Project	IEEE 802.16 Broadband Wireless Access Working Group < http://ieee802.org/16 >	
Title	Comments on SDD Security Key Exchange	
Date Submitted	2009-04-24	
Source(s)	Yih-Guang Jan, Yang-Han Lee, Hsien-Wei Tseng, Ming-Hsueh Chuang Tamkang University (TKU)	yihjan@yahoo.com
	Youn-Tai Lee, Chun-Yen Hsu Institute for Information Industry (III)	lyt@nmi.iii.org.tw
	Shiann-Tsong Sheu National Central University (NCU)	stsheu@ce.ncu.edu.tw
	Whai-En Chen National Ilan University (NIU)	wechen@niu.edu.tw
Re:	Category: SDD comments / Area: Chapter 10 (MAC) "Comments on SDD 10 MAC"	
Abstract	Comments on SDD Security Key Exchange	
Purpose	To be discussed and adopted by TGM for the 802.16m SDD.	
Notice	<i>This document does not represent the agreed views of the IEEE 802.16 Working Group or any of its subgroups. It represents only the views of the participants listed in the "Source(s)" field above. It is offered as a basis for discussion. It is not binding on the contributor(s), who reserve(s) the right to add, amend or withdraw material contained herein.</i>

Comments on SDD Security Key Exchange

Figure 1 Initial or Re-authentication - Key Derivation and Exchange

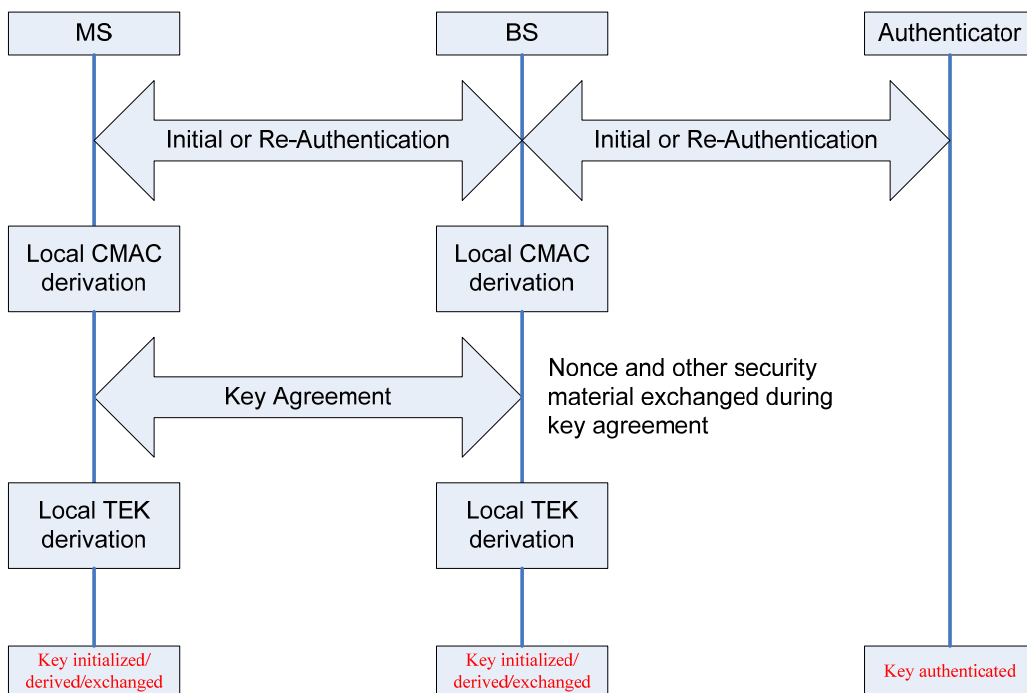
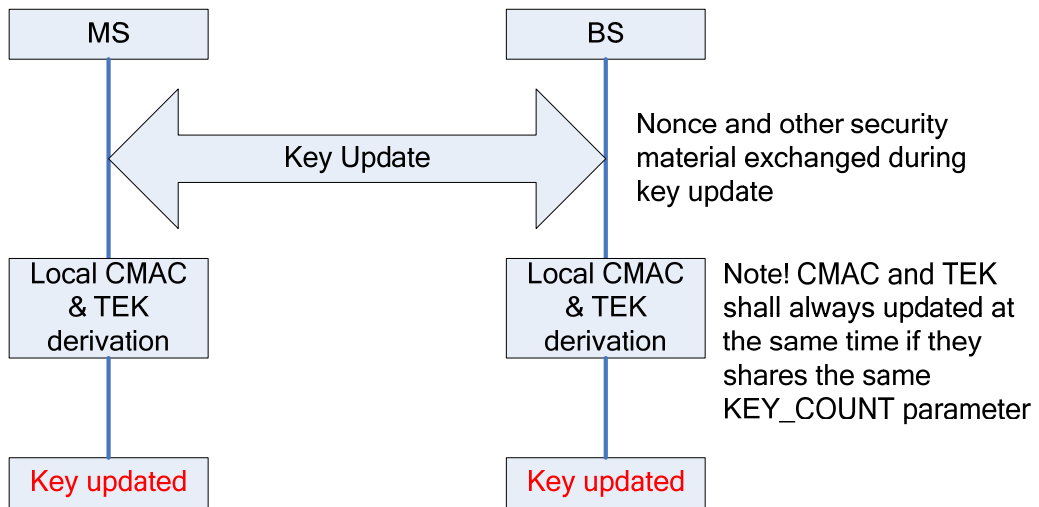
This contribution provides the corrected SDD text proposal to Key Exchange. In Figure 18 and Figure 19, they have some errors and are corrected.

[In IEEE 80216m-08_003r8, Section 10.6.3.2, Replaced by the following corrected text]
